V2500-A1/A5 SERIES PROPULSION SYSTEMS SERVICE BULLETIN

This document transmits Revision 1 to Service Bulletin EV2500-72-0394

V2500-ENG-72-0394

ENGINE – PROVIDE NEW LOOP CLAMP BRACKET FOR USE WITH NON AT RISK FUEL MANIFOLDS

Flange K
Fig 1

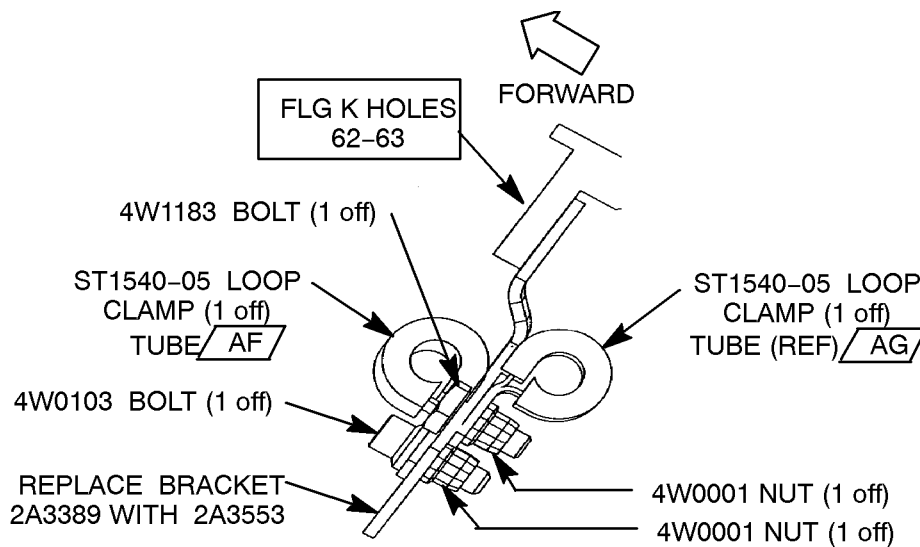
Replace bracket part number 2A3389 at hole 62 and 63 (as viewed facing rearward counting clockwise from the 12 o'clock position, see figure 1) with a redesigned bracket featuring a bent tab to provide additional bolt clearance.

- (1) Remove the existing bracket part number 2A3389 as follows:
 - (a) Locate the bracket on K flange at bolt holes 62 and 63. See Figure 1 for location of the part.

- (a) Install the new bracket on K flange at bolt holes 62 and 63. See Figures 1 and 2.
 - (b) Torque the flange nuts by the procedure specified in reference (3), Engine Manual, Chapter/Section 72-00-42, Installation-01.

Clipping view
Fig 2

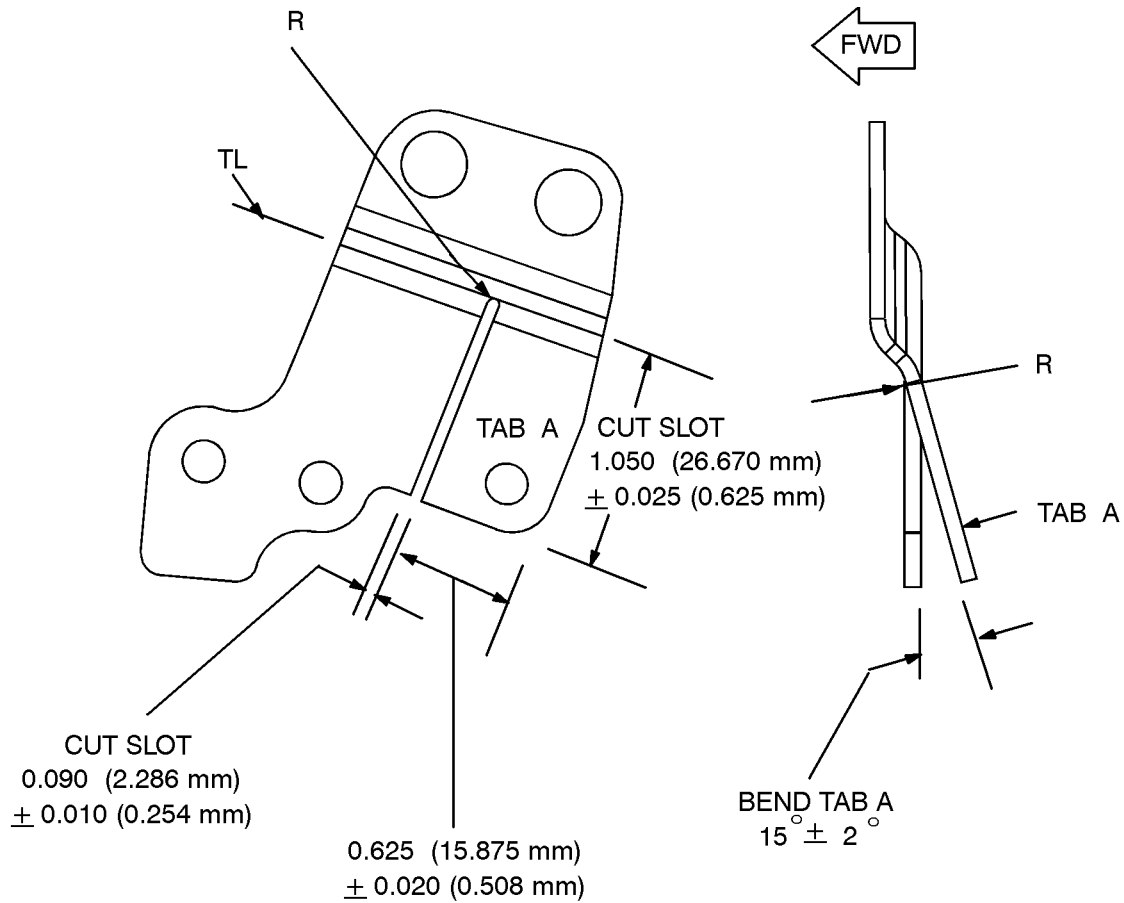
- (b) Remove the bolts and nuts holding the loop clamps to the bracket. See Figure 2.
 - (c) Slide the loop clamps out of the way.
 - (d) Remove the existing bracket part number 2A3389.

- (c) Attach the loop clamps to the new bracket. See Figure 2.
 - (d) Torque the clamp nuts to 36 to 40 Lbfin (4,069 to 4,519 Nm).
- (4) Recording Instructions

Family tree for bracket
Fig 4

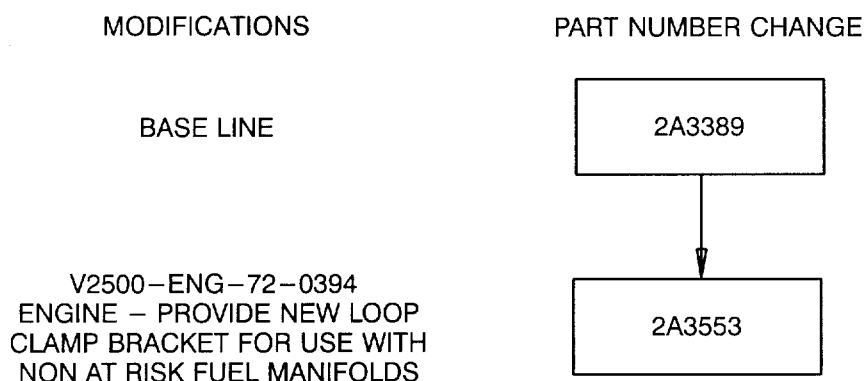
Parts Progression To Show the Changed Part in Relation to Other Parts
